**Town of Kittery Maine
 Planning Board Meeting
 August 13, 2020**

ITEM 4— 8 Wentworth Street, Rice Public Library – Preliminary Site Plan Review

Comments on the July 24 2020 submission

EXISTING CONDITIONS SURVEY

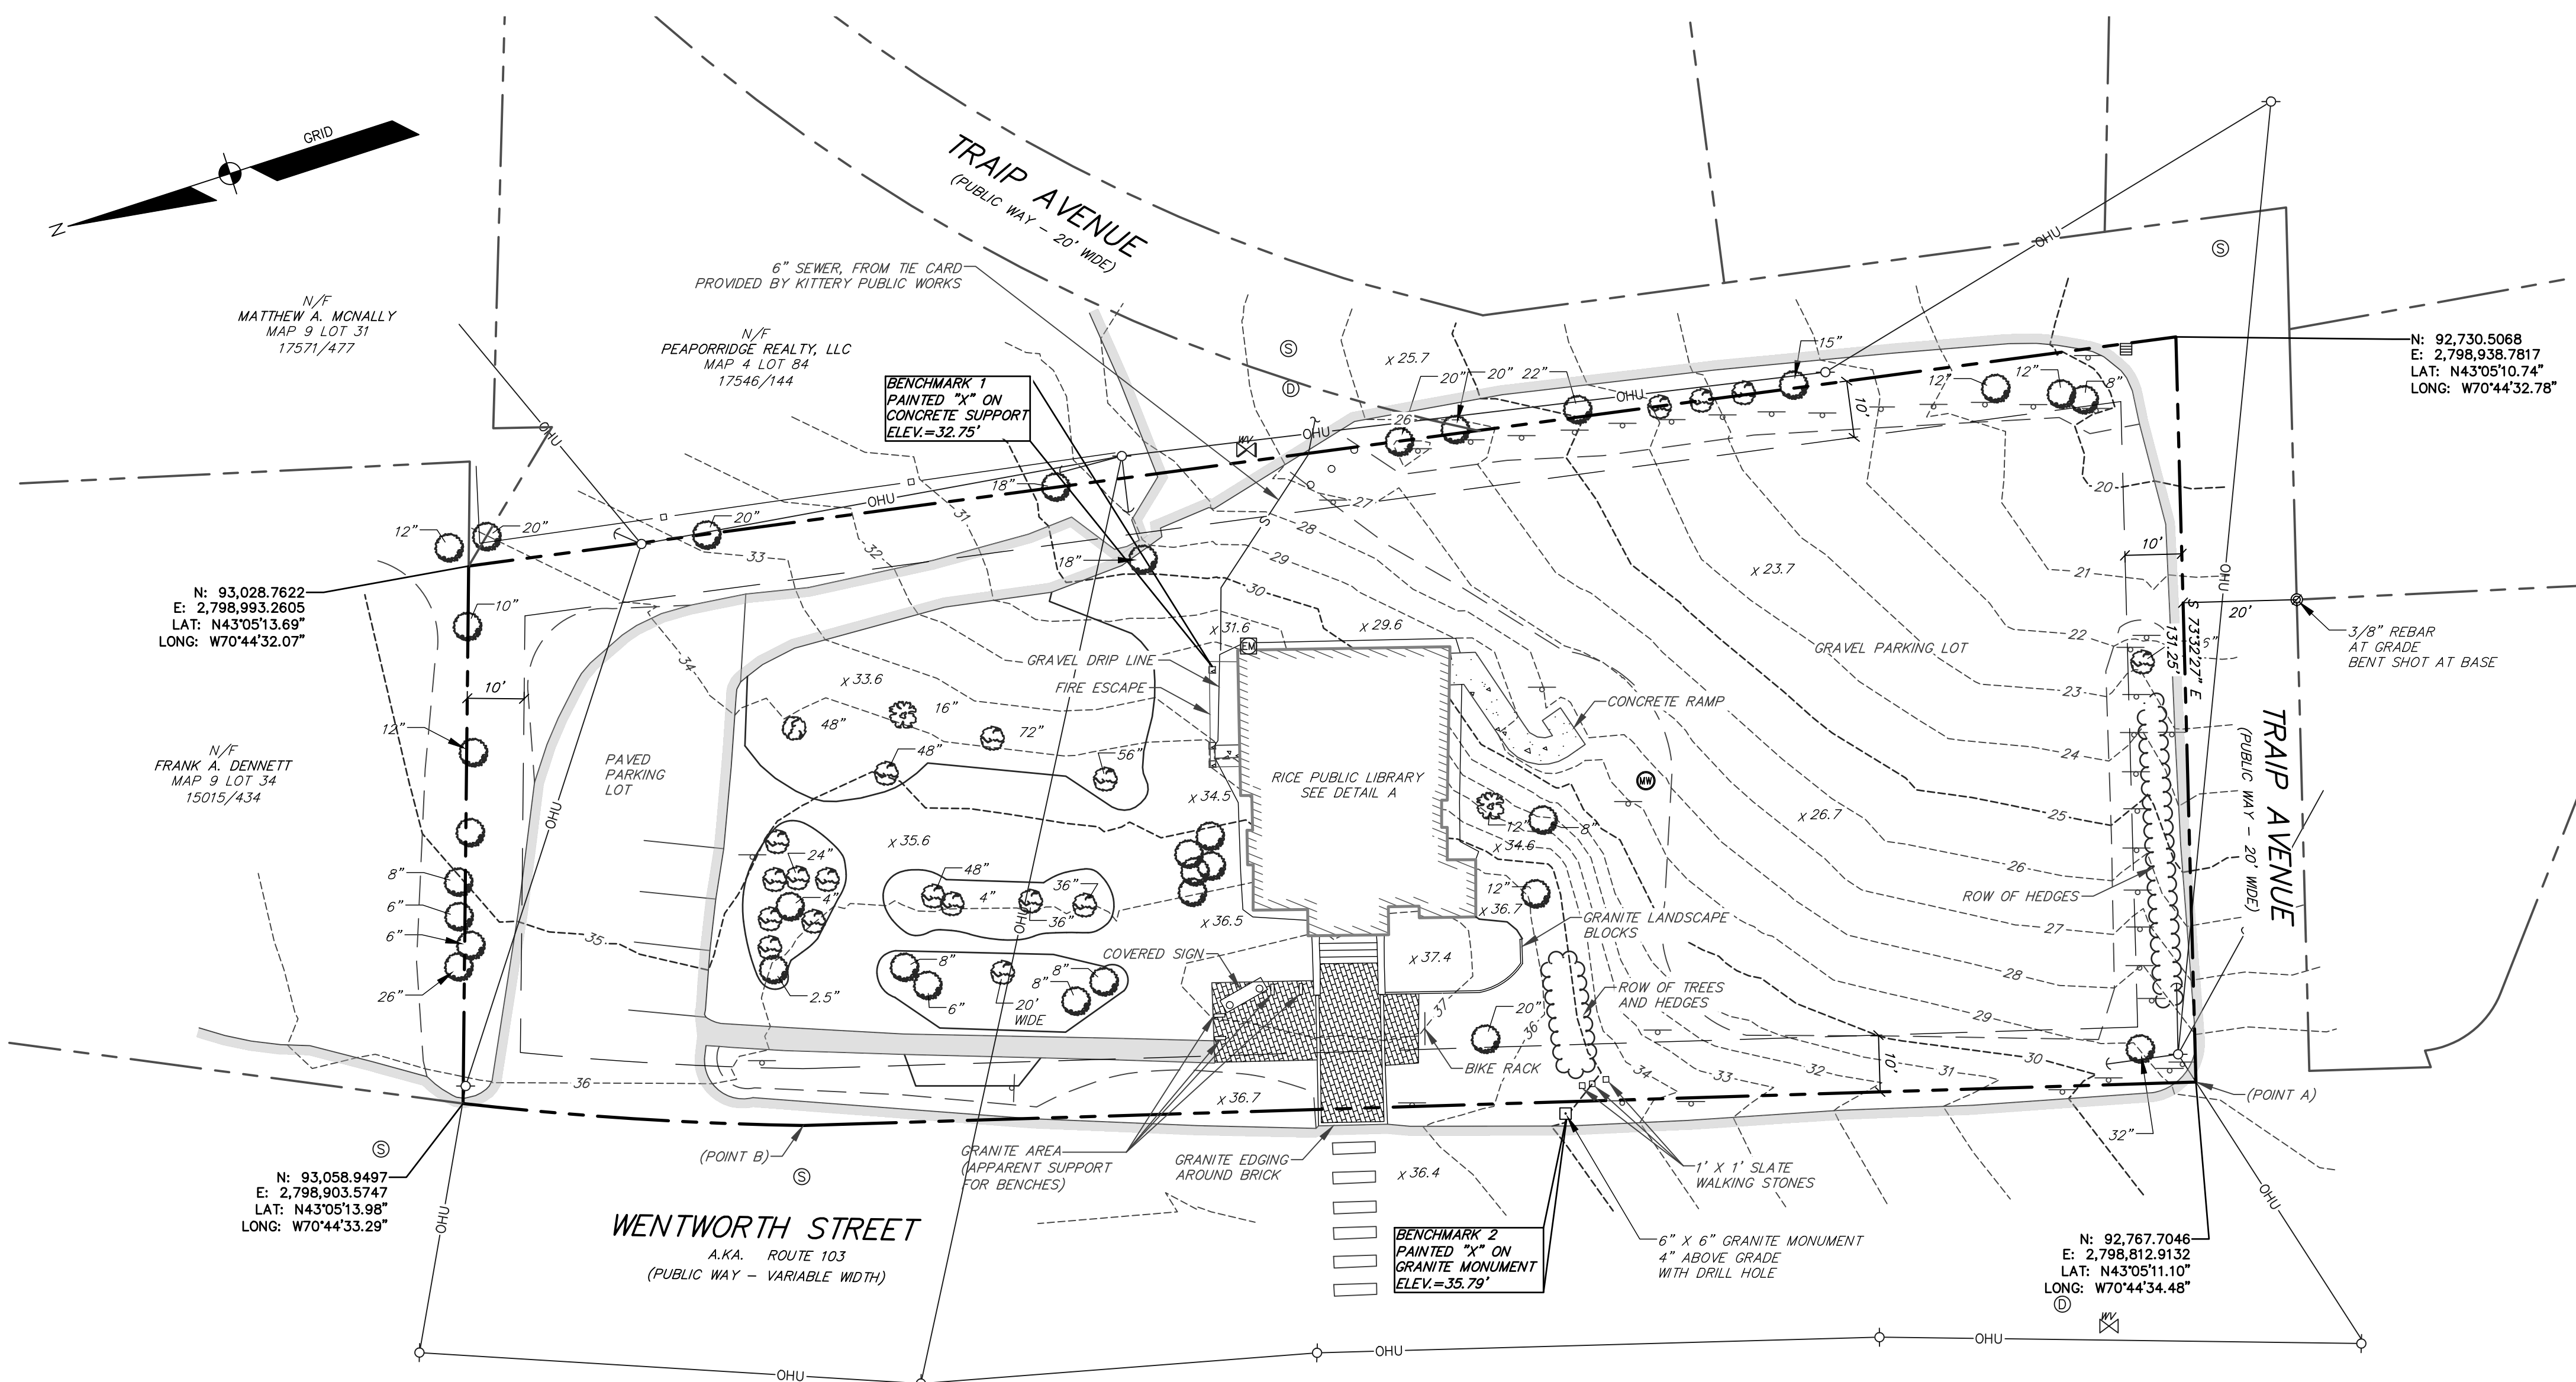
8. The "Surveyor's Statement" on Sheet 1 of 1 needs endorsement.
9. While an erosion control plan is provided by the Applicant there appears a construction sequencing plan has not been furnished. The Applicant should provide a construction sequencing plan to the Board for review and approval.

SITE PLAN OF RICE PUBLIC LIBRARY
 8 WENTWORTH STREET
 KITTERY, MAINE 03904

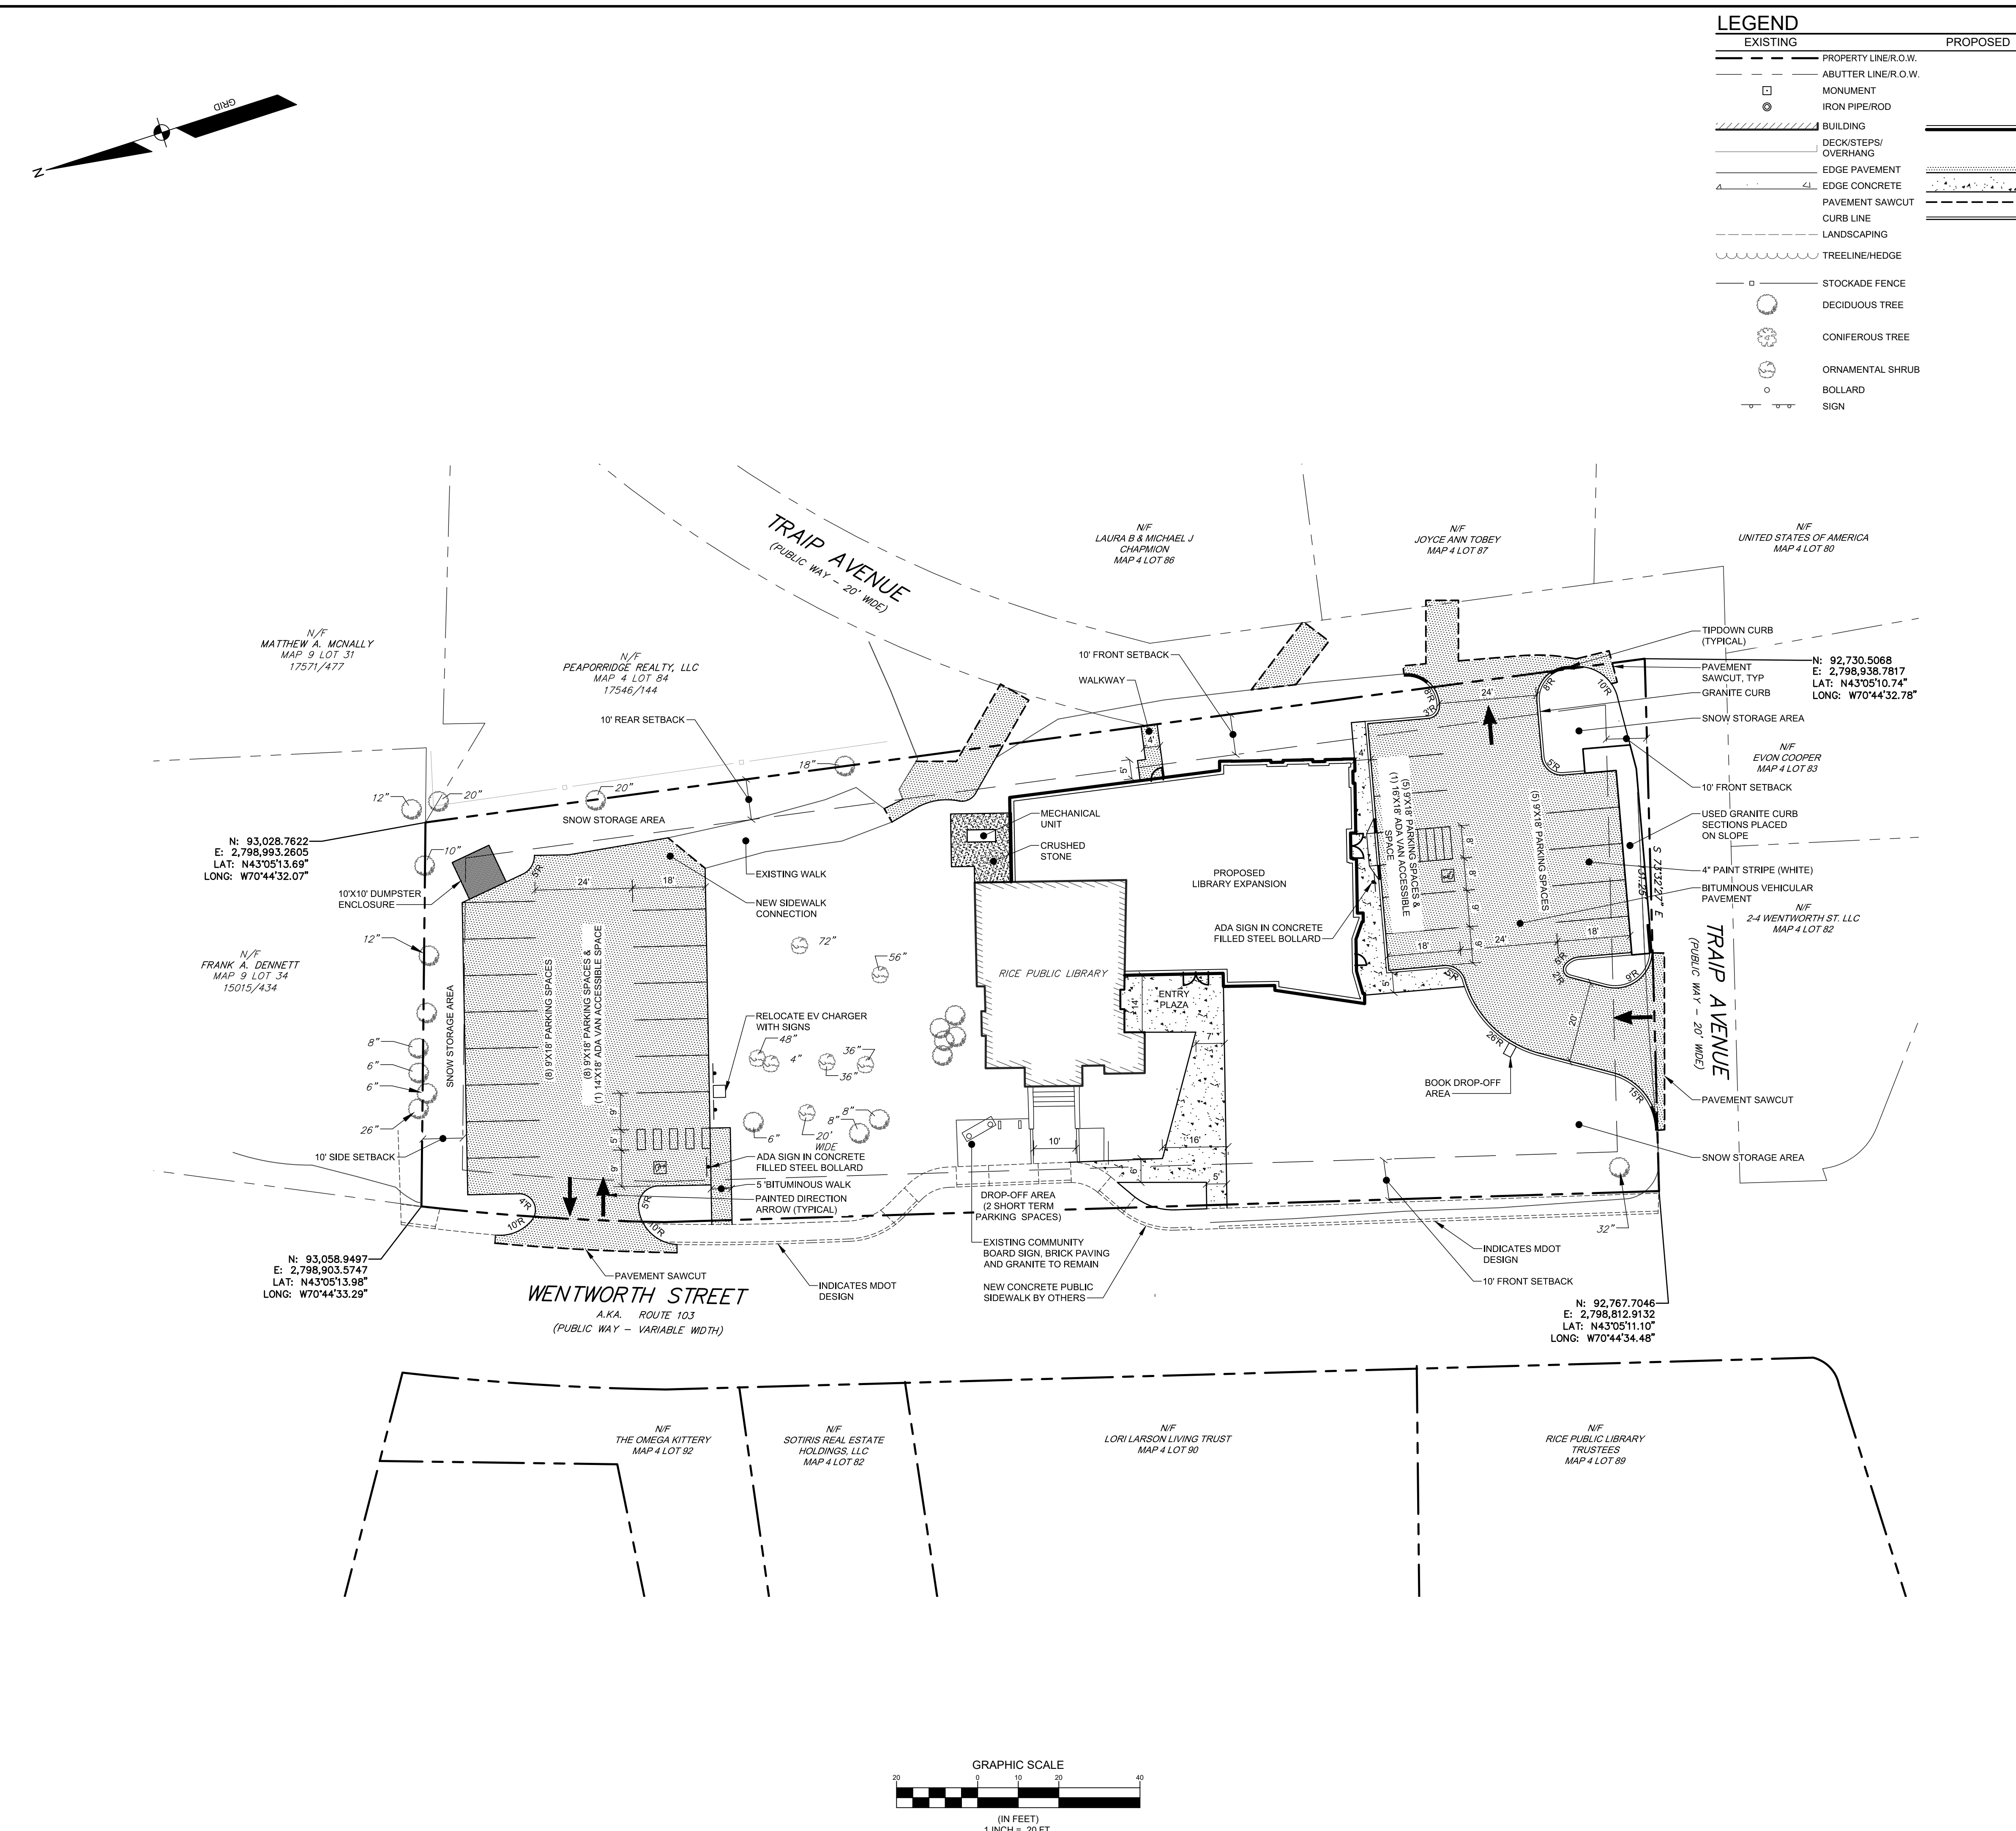
6. The proposed location of the dumpster on the northeast corner of the upper lot appears to encroach on the side yard setback. The Applicant needs to confirm if this is the case and, if so, propose an alternative location that satisfies the requirement, pursuant to §16.3.2..14.D Standards.

8. A dumpster enclosure has been added to the upper parking lot.

The dumpster enclosure has been added to the upper parking lot.

LANDSCAPE PLAN
 OF:
RICE PUBLIC LIBRARY
 8 WENTWORTH STREET
 KITTERY, MAINE 03904
 FOR:
LASSEL ARCHITECTS
 P.O. BOX 370, 370 MAIN STREET
 SOUTH BERWICK, MAINE 03908

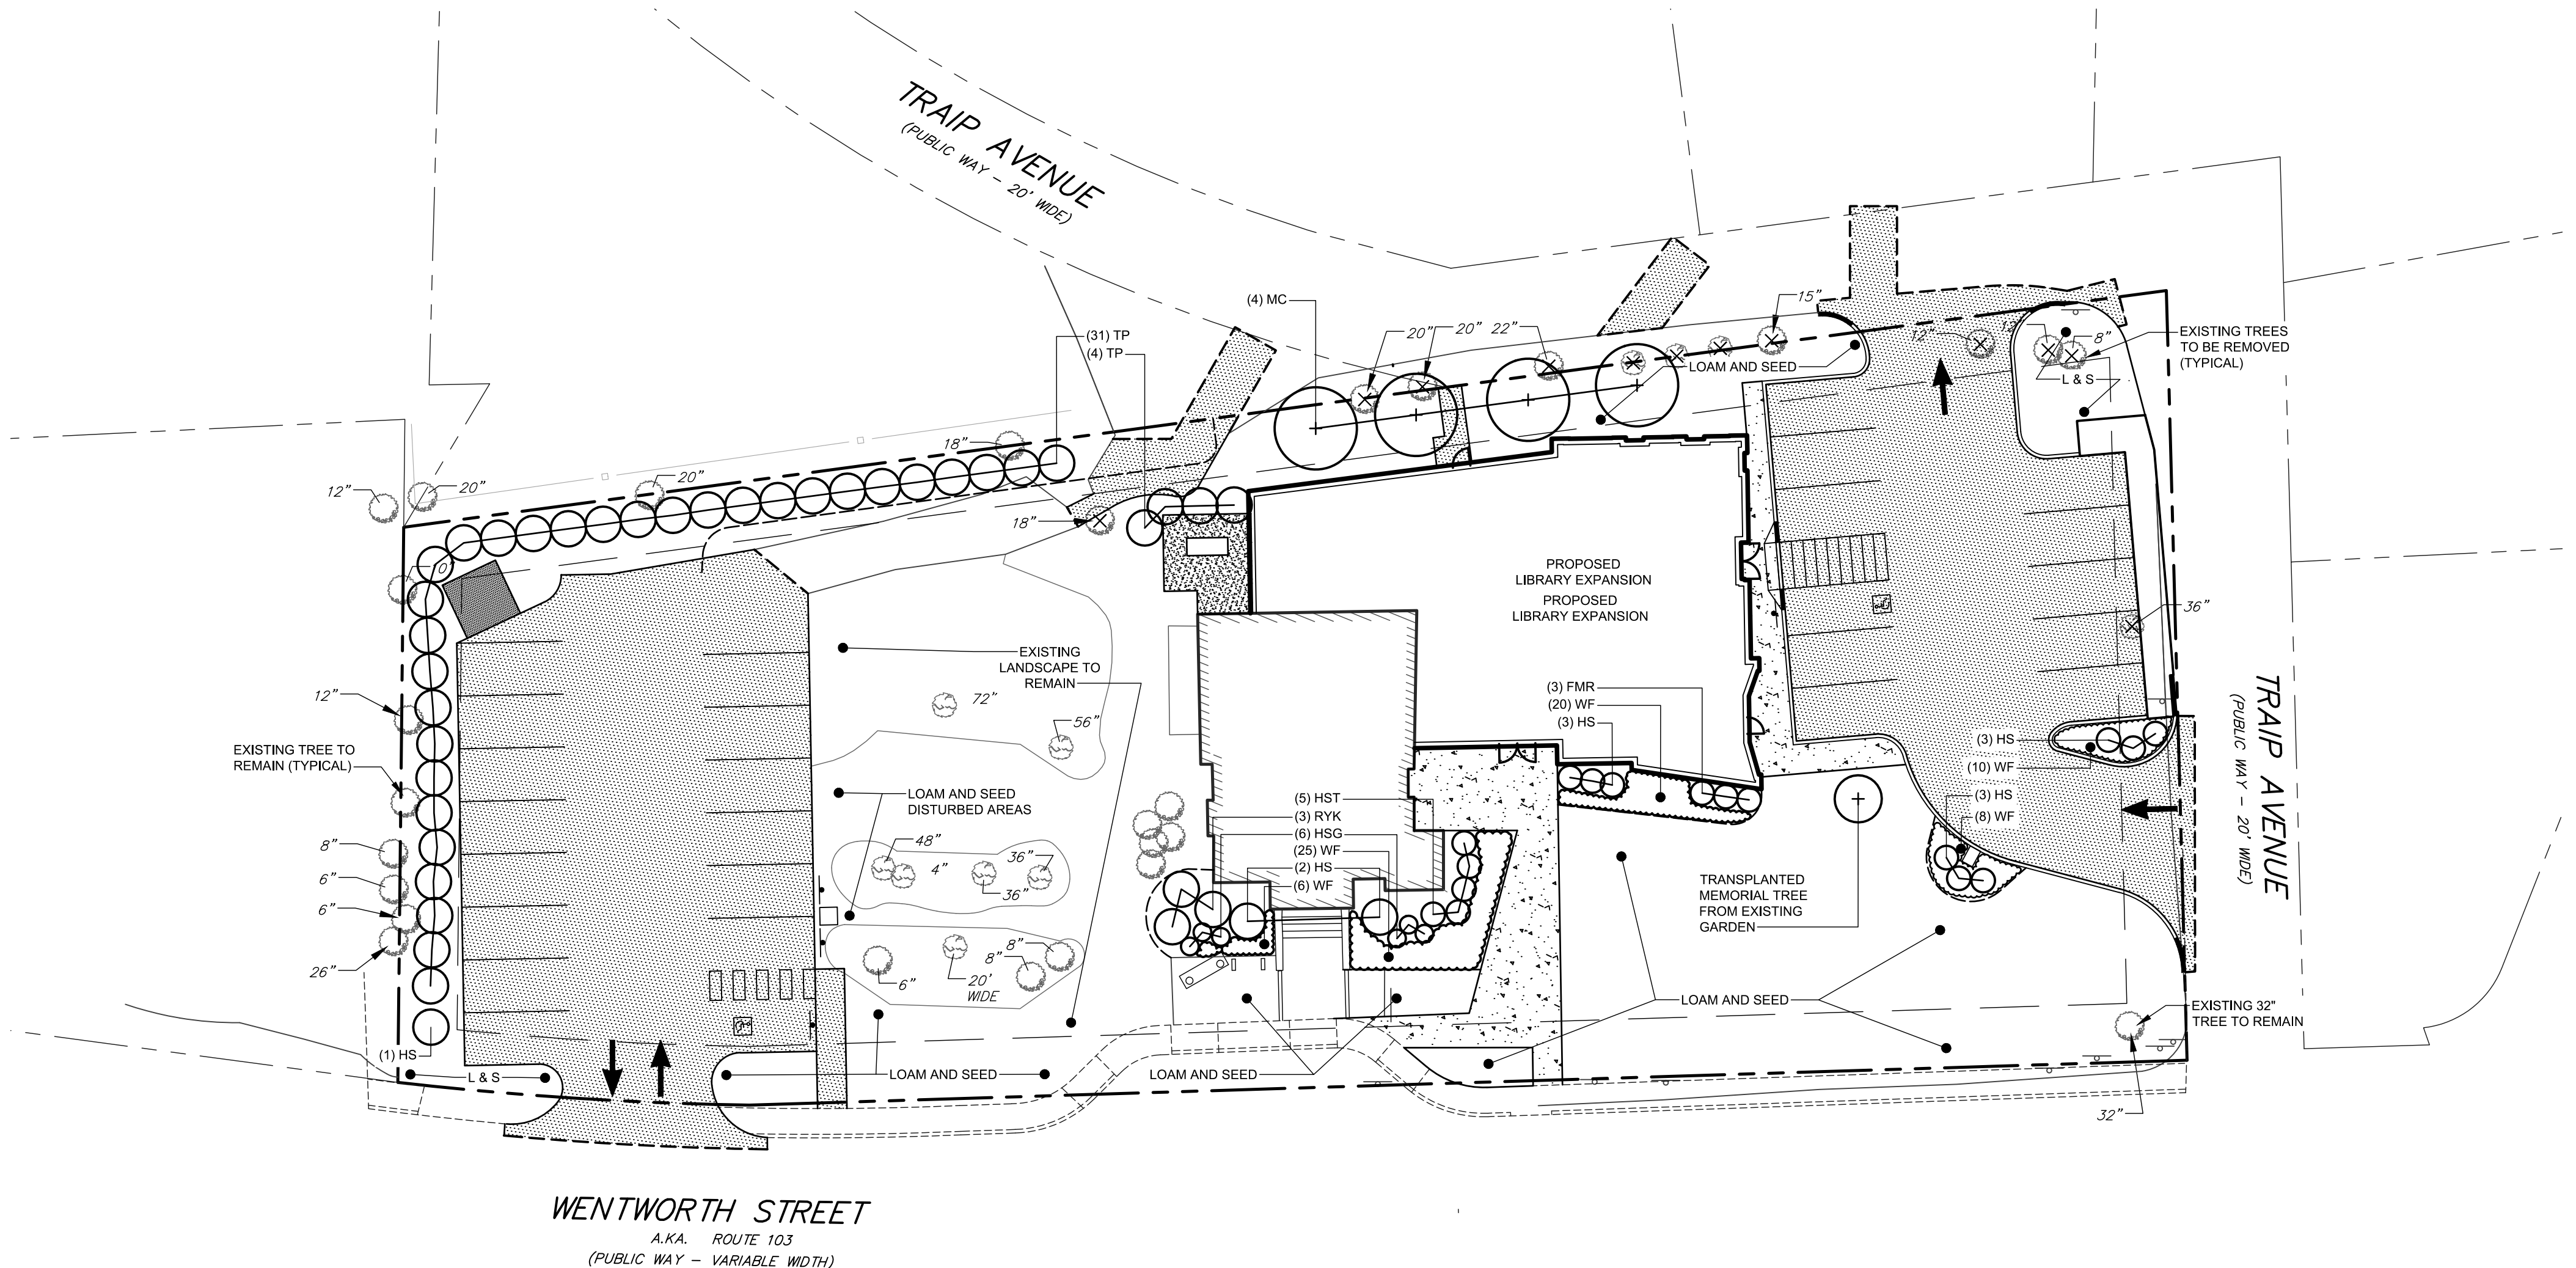
1. The Book and Page reference on Map 4 Lot 84 is incorrect. The correct reference should read as follows: 17564 / 144.
2. It is unclear how the tree and its root system located on the corner of Traip and Wentworth shall be preserved during the re-grading of the site. The Applicant should provide an updated site plan illustrating how this will be accomplished along with other trees slated to be preserved or transplanted.

3. It is unclear if there will be enough snow storage capacity located along the eastern edge of the upper parking lot given the type of trees proposed (*Thuja plicata*—spring grove) and whether or not the *Thuja plicata* are salt tolerant. The Applicant should confirm the salt tolerance of the proposed vegetation and whether there will be adequate space for current and future snow storage. In addition, the Applicant should comment on the proposed spacing of the spring grove plants.
